Product Change Notification

Change Notification #: 113190 - 00
Change Title: Intel® Server System R1304GL4DS9
PCN 113190-00, Product Design
Update the System Rear Panel
Date of Publication: August 01, 2014

Intel has implemented the following change on the Intel® Server System R1304GL4DS9:

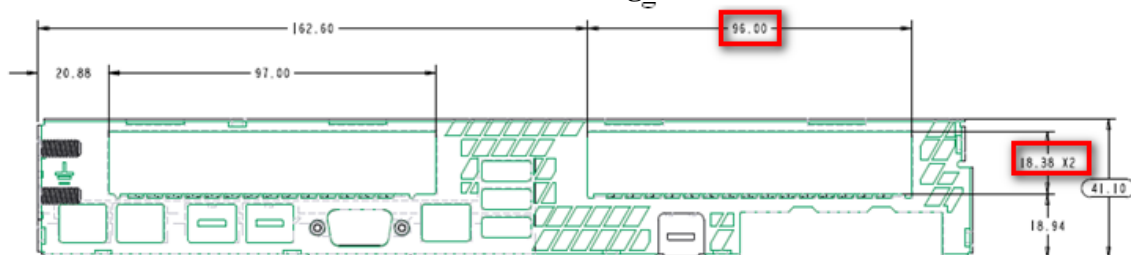
Update the system rear panel so that more PCIe devices and cable connectors can mechanically fit into the system. Please refer to the following pictures for details:

Pre-change:

Post-change:
